RE: SITE PLAN (SP2018-016), Shipman Office Building

Project Number:	SP2018-016
Project Name:	Shipman Office Building
Project Type:	SITE PLAN
Applicant Name:	MERSHAWN ARCHITECTS
Owner Name:	Shipman, Clay
Project Description:

AGENDA DATE:	07/10/2018
APPLICANT:	Wayne Mershawn of Mershawn Architects
AGENDA ITEM:	SP2018-016; Site Plan for Office Building Use

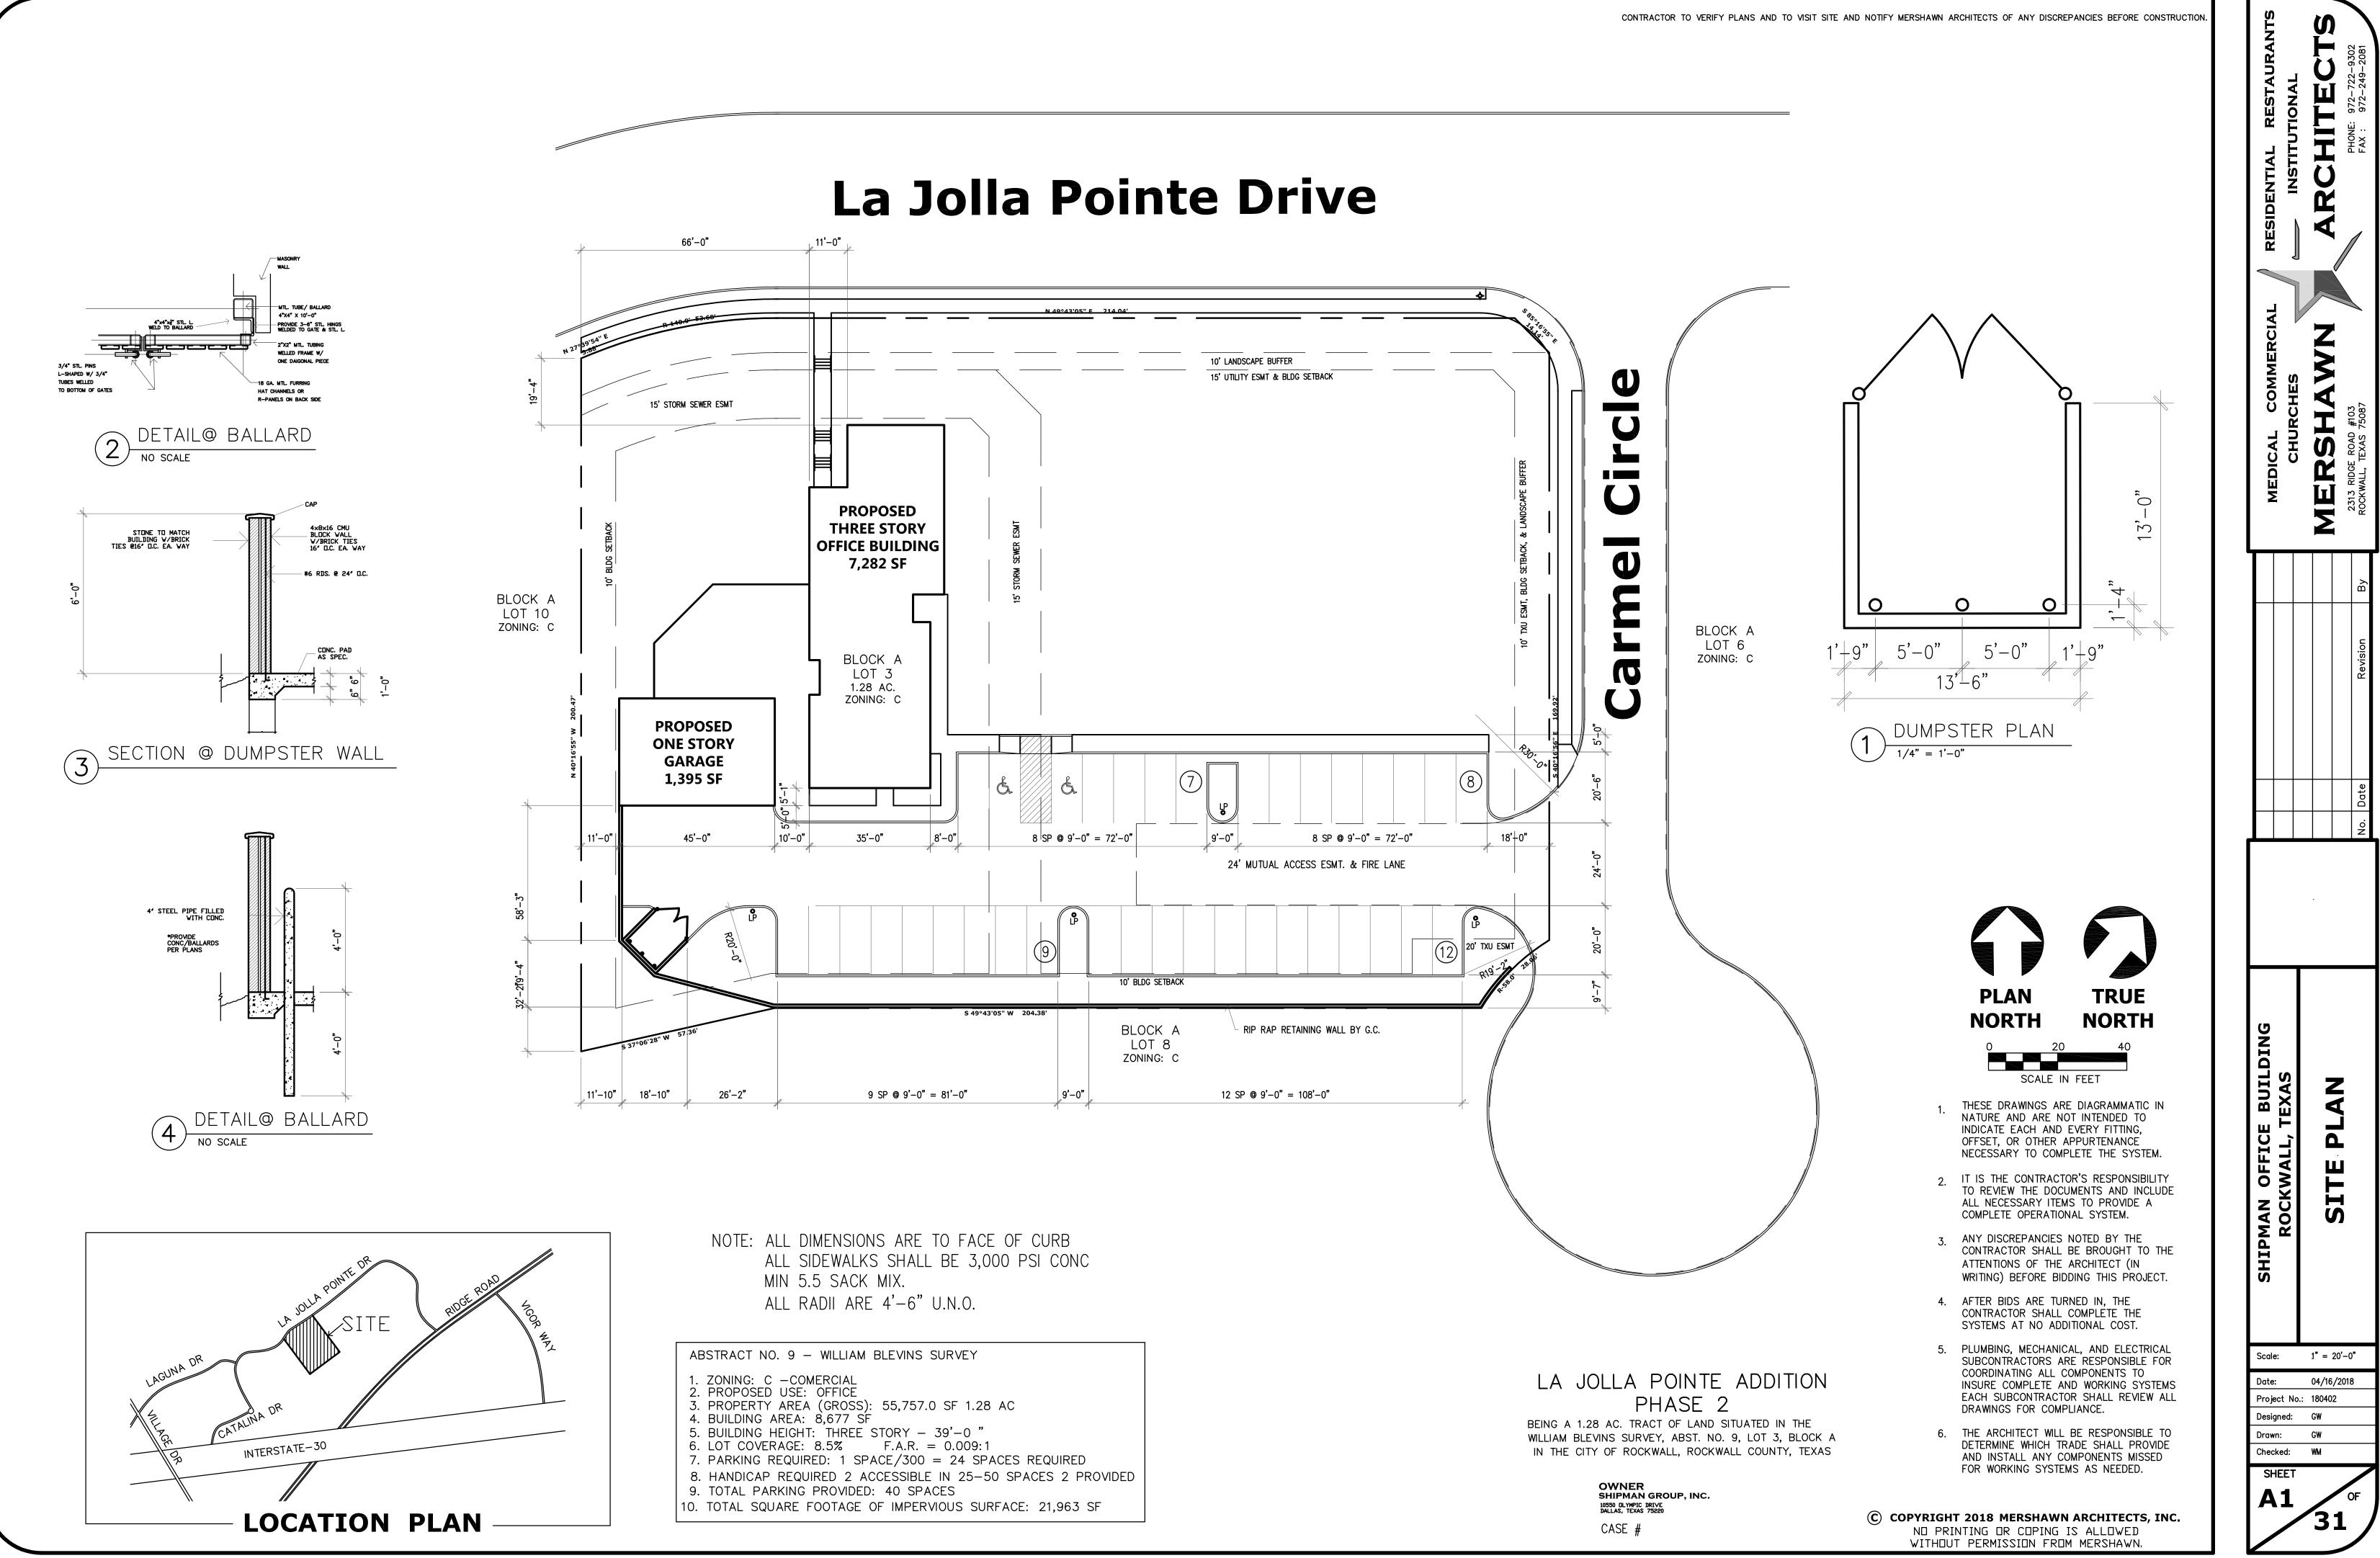
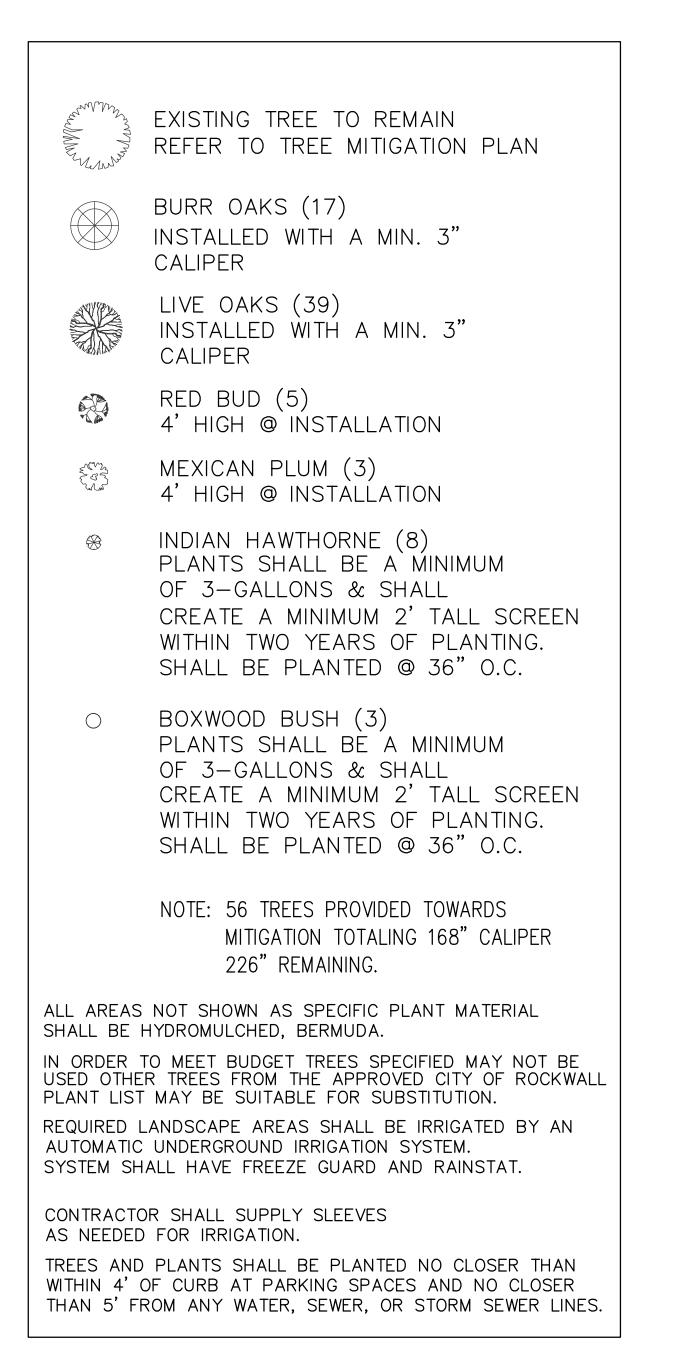
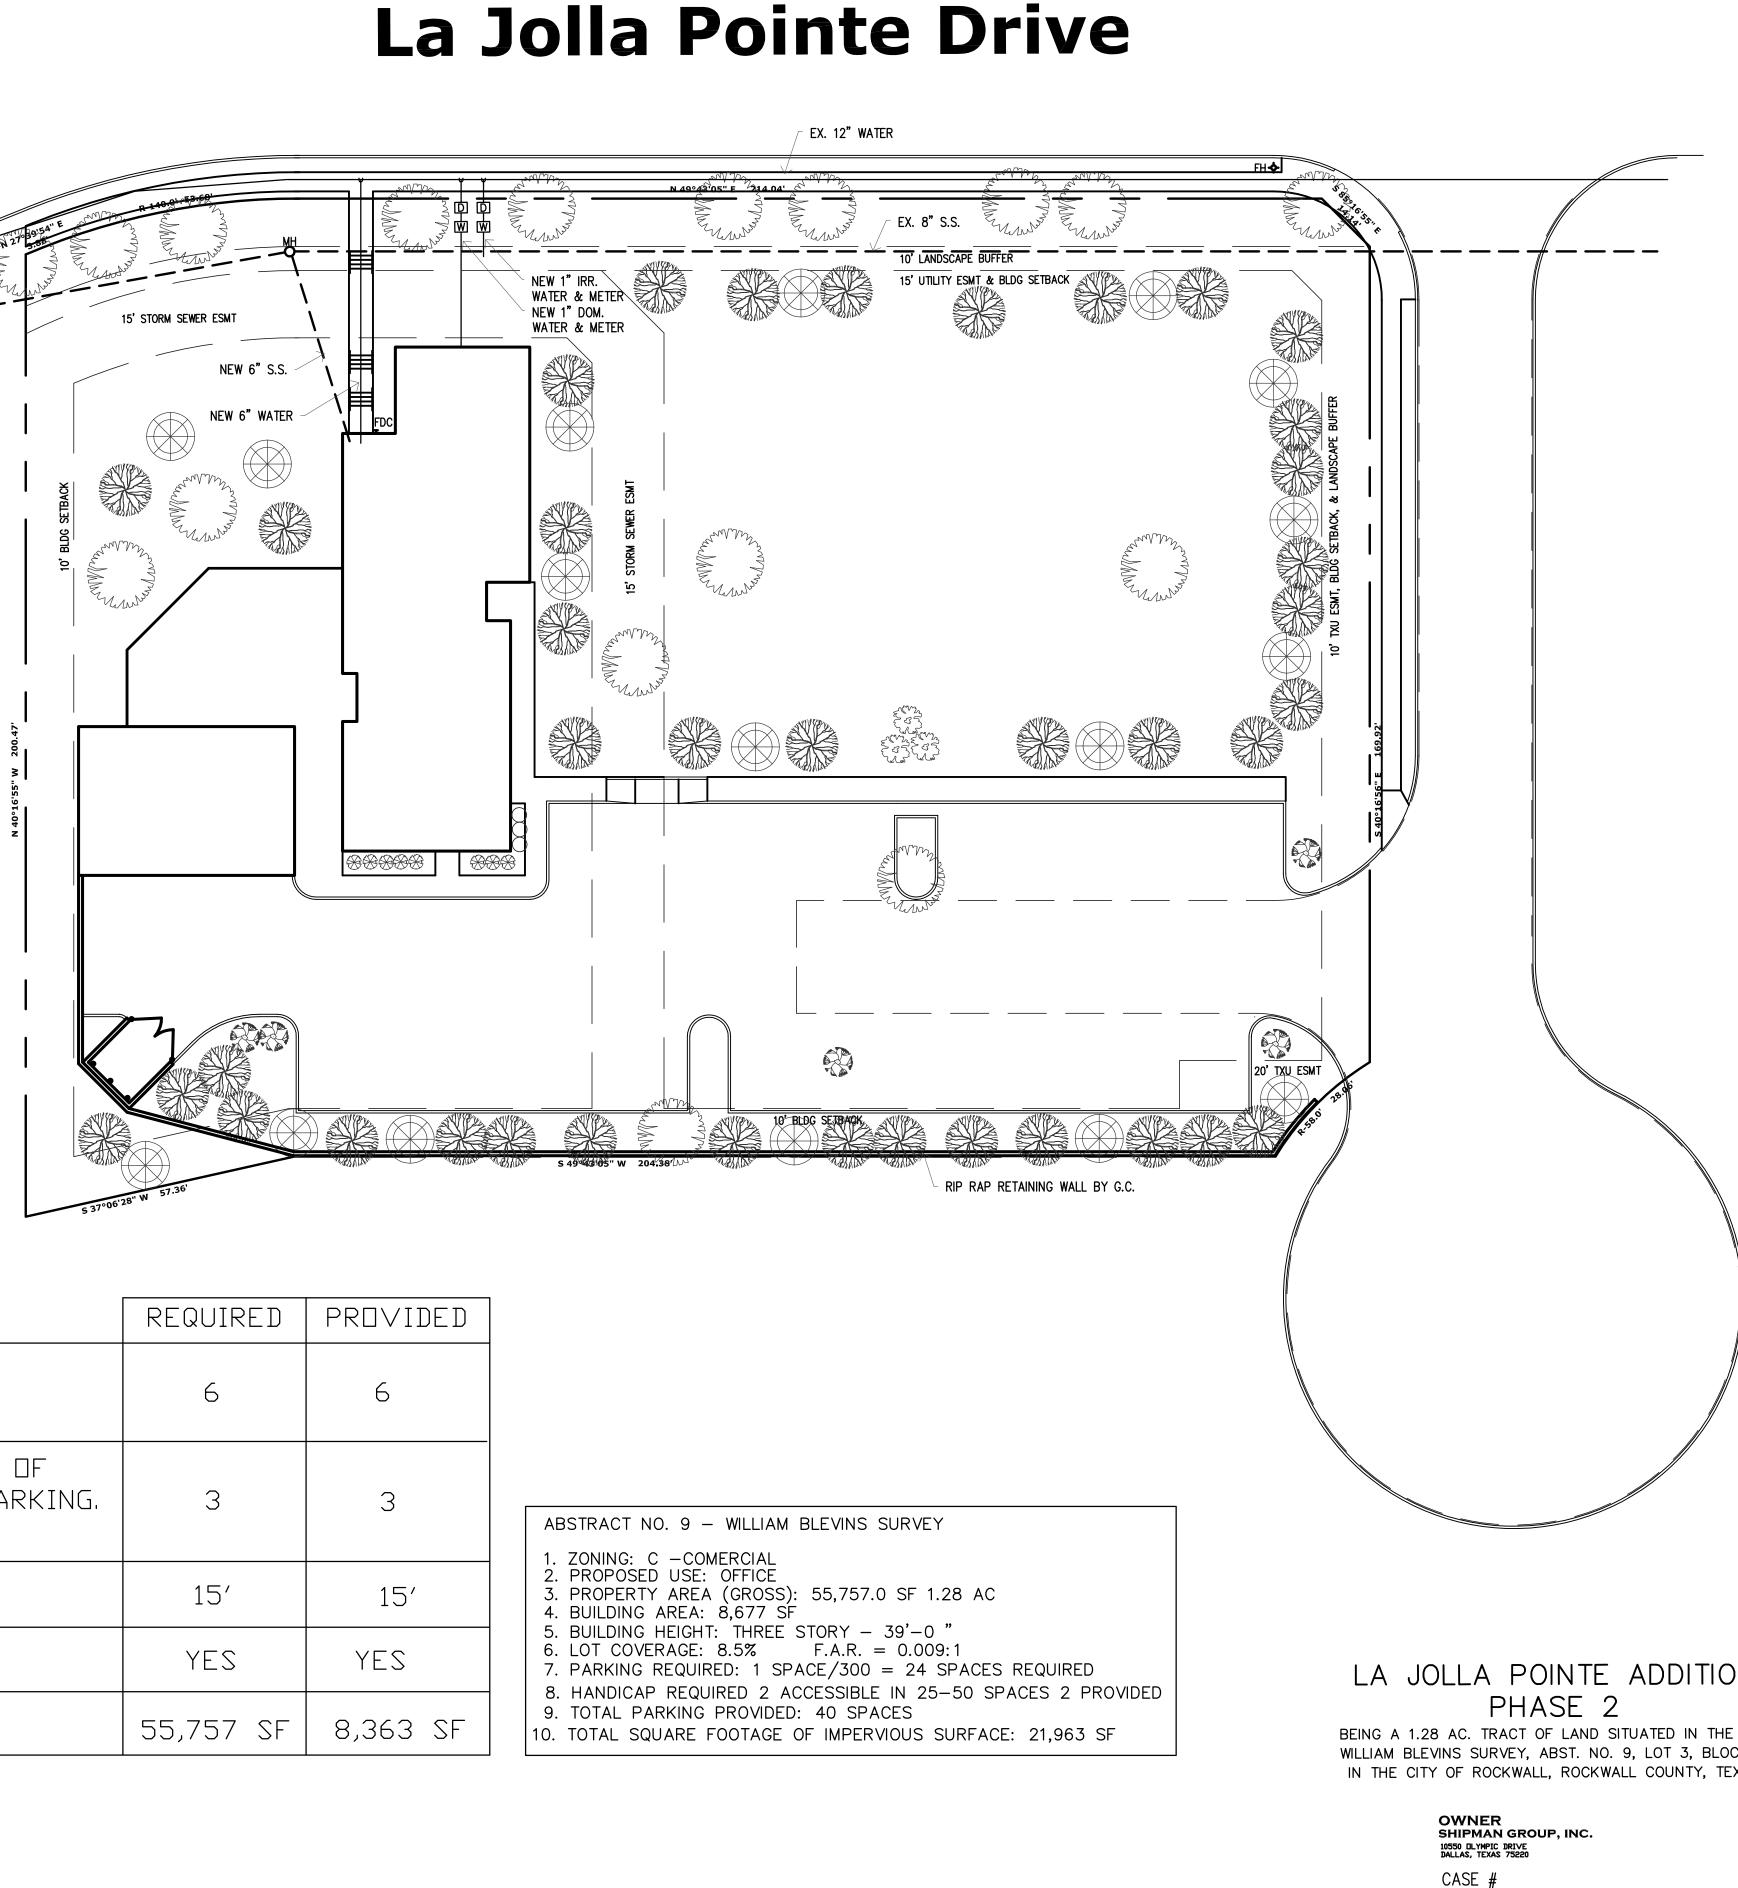
1. Correct No. 1 of the Legend to indicate minimum number of Street Trees Required to equal1 tree per 50-linerar feet of Rights-of-Way, including the portion of Carmel Circle that is not shown on plan (i.e. minimum of 6 for La Jolla Pointe + 3 for east portion of Carmel Circle + 6 for south portion of Carmel Circle. Provided to equal minimum required of 15 trees.

2. Correct No. 5 of the Legend that indicates total landscaping required of 55,757 SF to 8,363 SF (i.e. 15% required). Also change the minimum required to 15% (not 20%).

4. Provide label for 'Carmel Circle' .

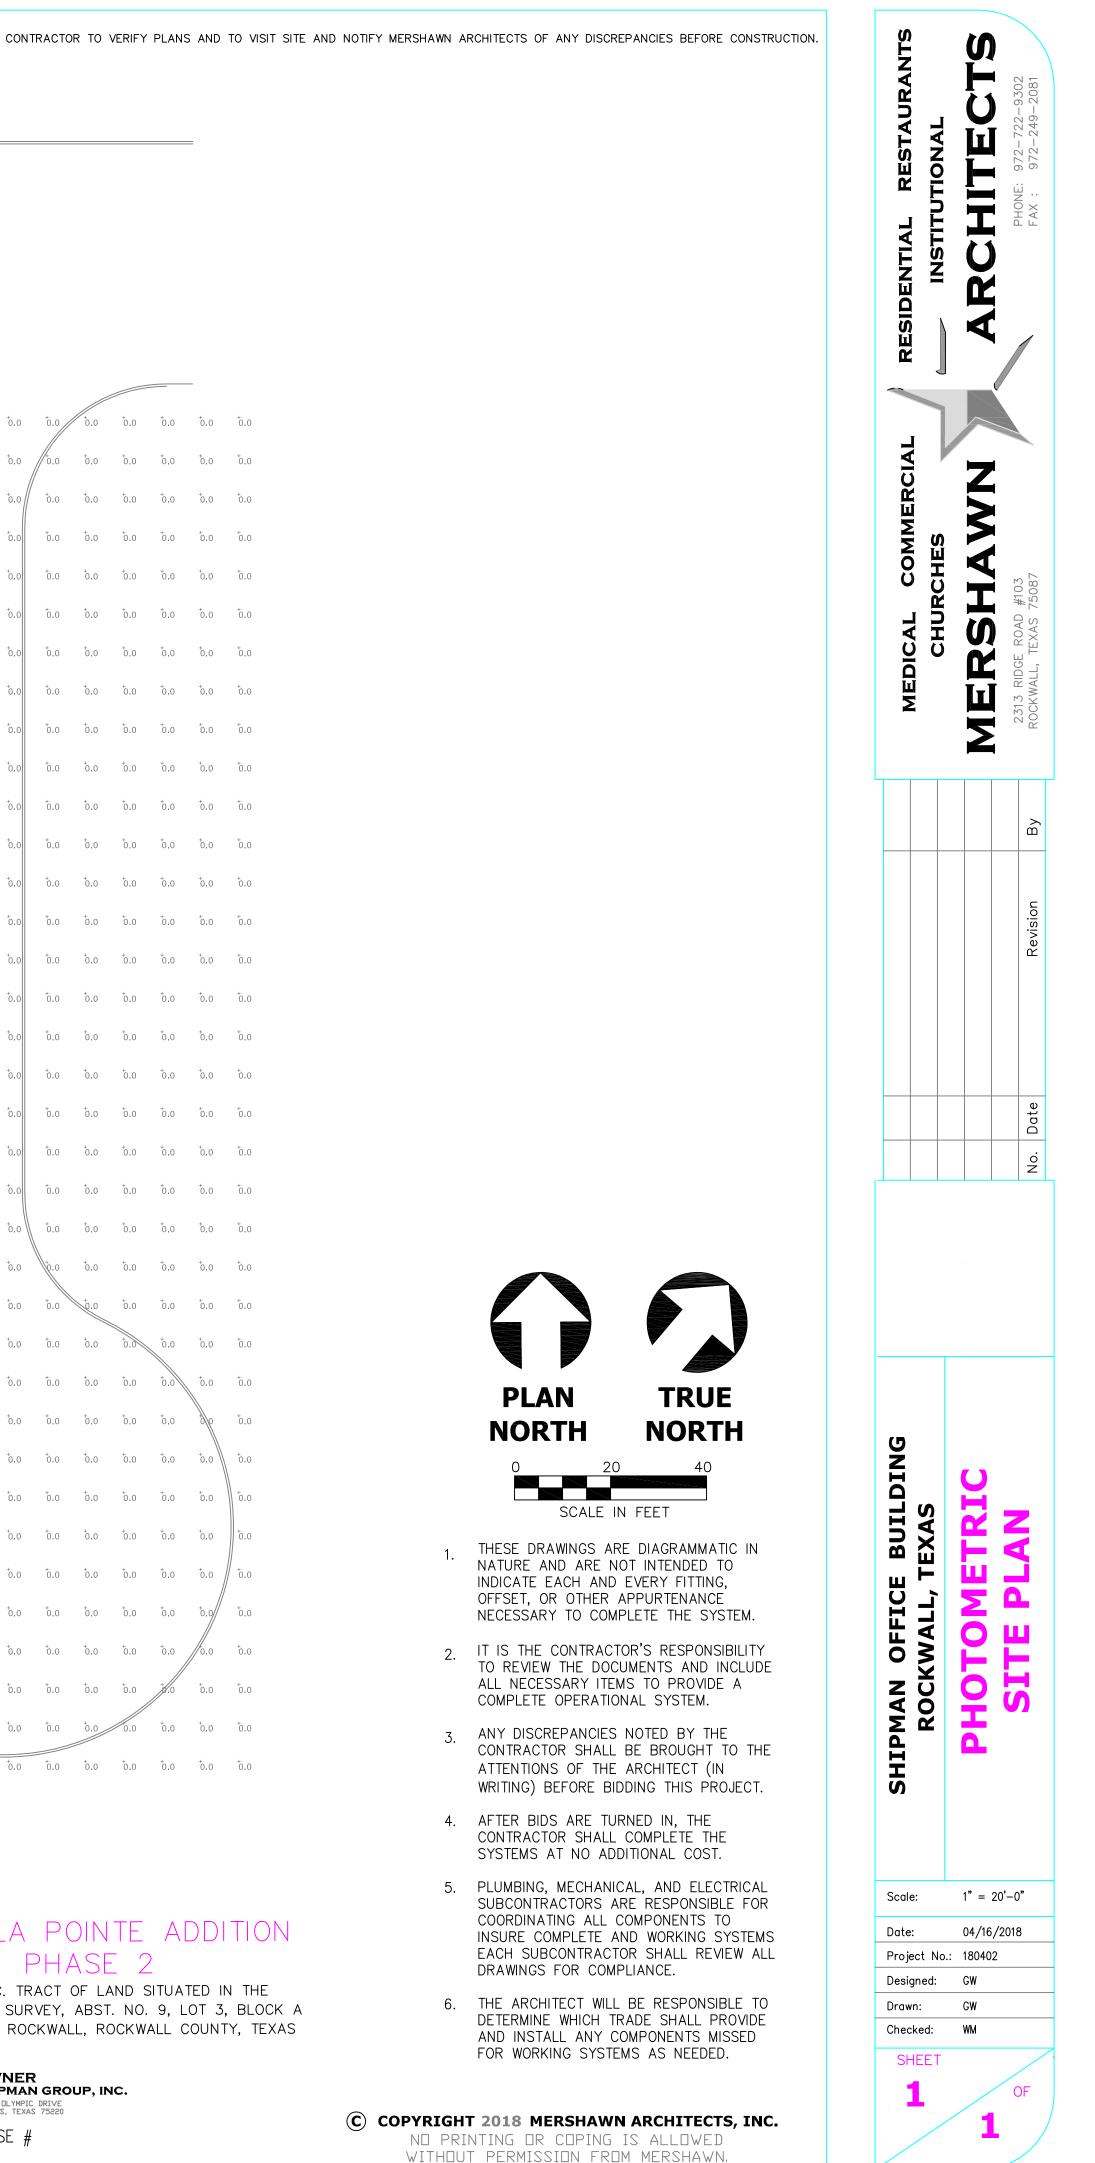
2. Verify parking count. Legend states 40 spaces provided, I count a total of 36 parking spaces.

3. Where are HVAC units located? See screening requirements and provide appropriate screening for all units
